Service Advisory

W-154

Models Affected: W-83MC (12AV83MC790).

Subject: **Input Pulley Differences On The 618-04378 & 618-04378A Transmissions.**

FIGURE 1

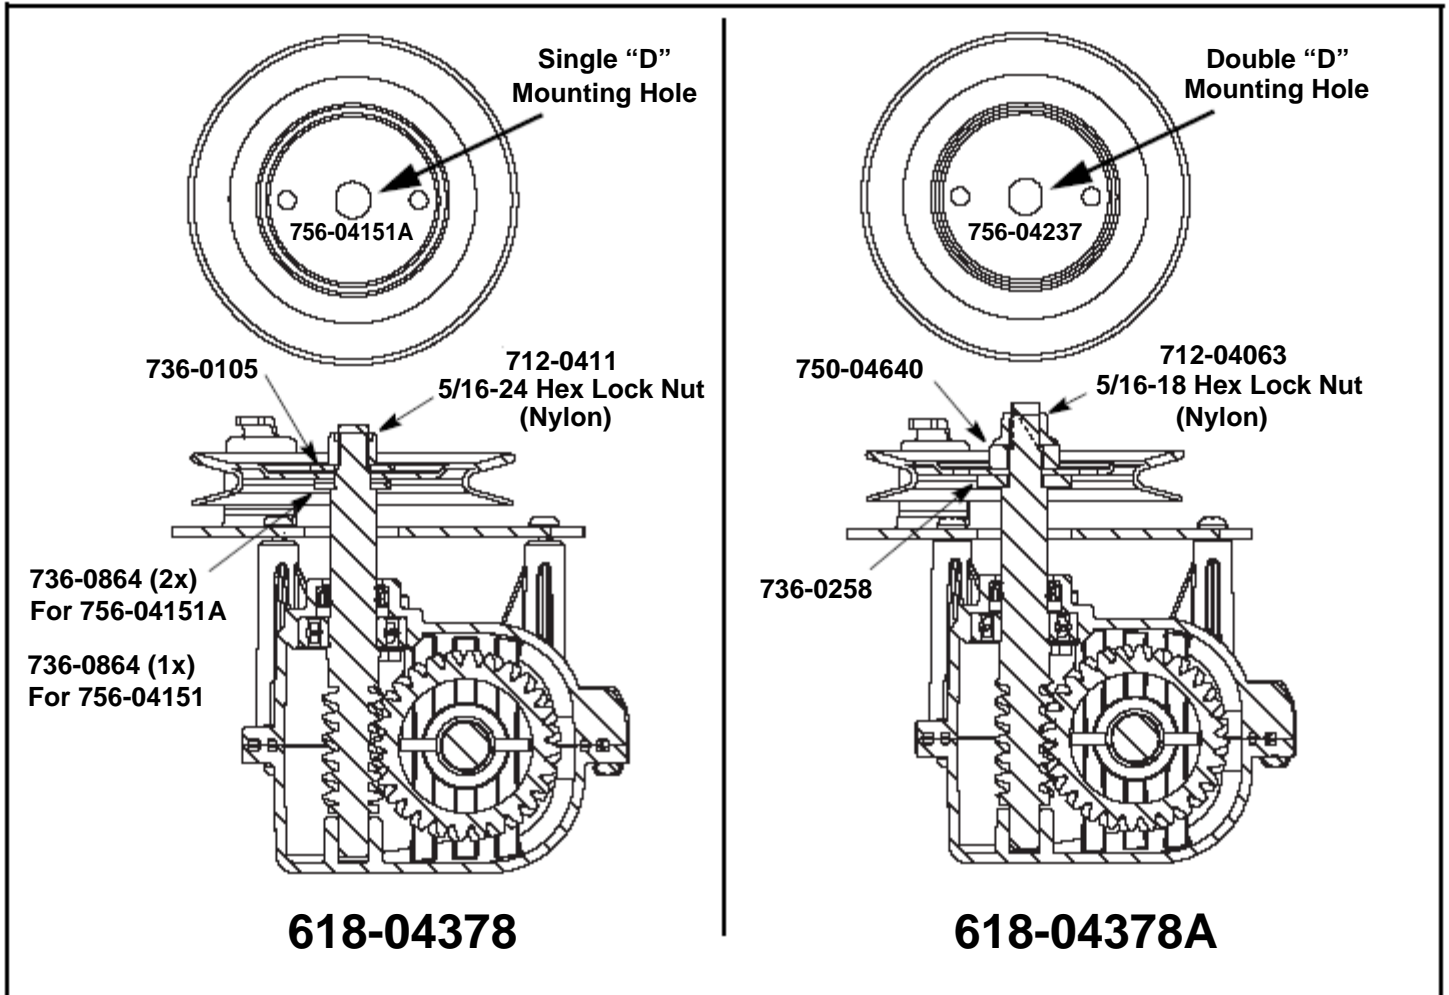
PURPOSE: To define the external differences between the 618-04378 & 618-04378A transmission input shaft & pulley.

The 618-04378 & 618-04378A transmissions are interchangeable. If it becomes necessary to replace the transmission's input pulley, make note of the existing pulley's center mounting hole configuration & order the appropriate pulley. Also note that the threads on the end of the input shaft & mounting hardware are also different.

Difference shown in Figure 1 on the reverse side of this Advisory.
